**STAFF REPORT**  
**COMMUNITY DEVELOPMENT DEPARTMENT**

HEARING DATE: 4/6/2021  
TO: Mayor & City Council  
FROM: Alan Tiefenbach, Associate Planner  
208-489-0573  
SUBJECT: FP-2021-0007  
Daphne Square Final Plat  
LOCATION: 4700 W. McMillan Rd.  
NE corner of N. Black Cat Rd and W.  
McMillan Rd.

Final plat consisting of 28 buildable lots and 3 common lots on 4.97 acres of land in the R-15 zoning district, developing in a single phase.

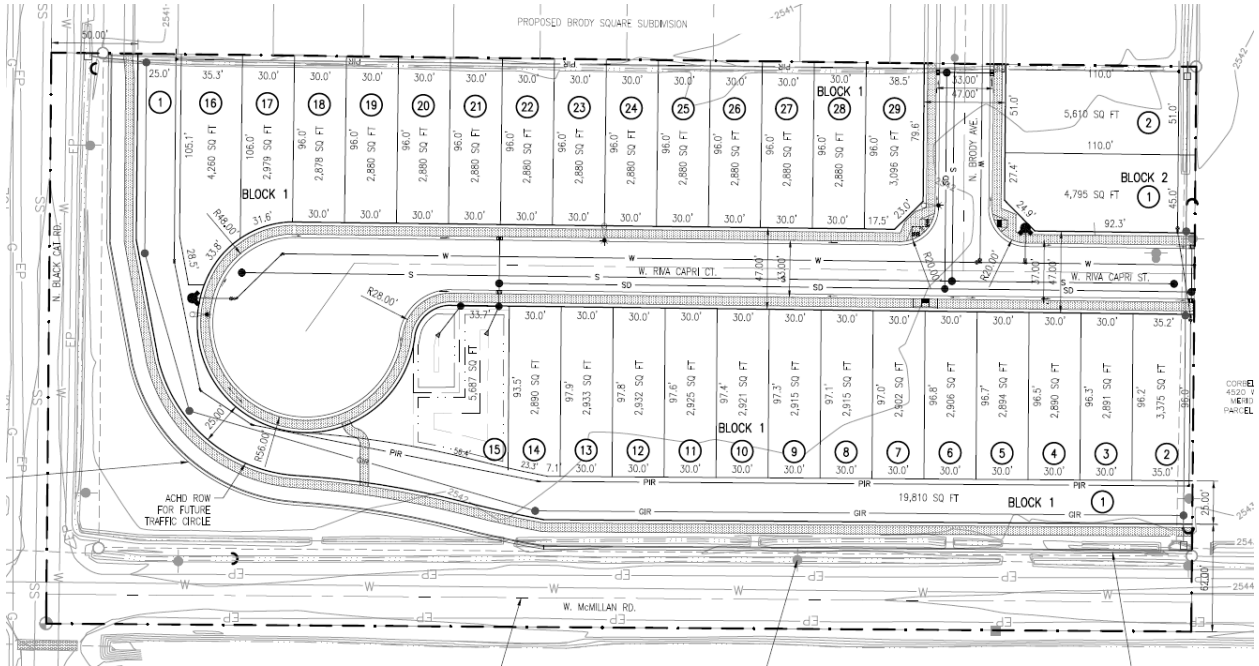
The applicant responded in a February 25, 2021 email that the representative for Brody Square Subdivision stated they did not have the room for additional playground equipment in the central park in Lot 9, Block 3. Accordingly, the final plat indicates the additional open space as required in Option 2 (now shown as Lot 2 of Block 2). This results in slightly more useable open space than the approved preliminary plat.

## B. Final Plat (date: 2/14/2021)

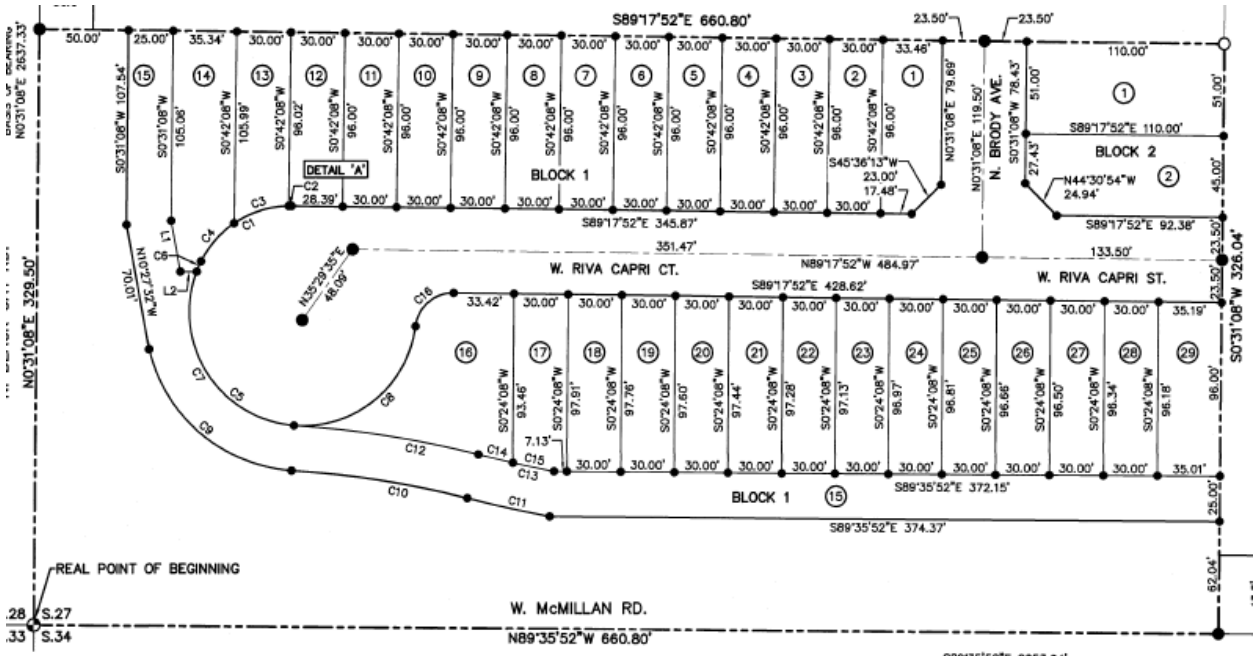
3. Prior to City Engineer signature on the final plat, the final plat prepared Idaho Survey Group LLC, stamped by Gregory G Carter, dated: 02/14/2021, included in Section V.B shall be revised as follows:

- a. Add "City of Meridian" to Note #2.
  - b. Add Lot 2, Block 2 to Note # 5.
  - c. Add a note which states "Rear setbacks of all homes in Lots 1-14, Block 1 shall be 20 feet. "
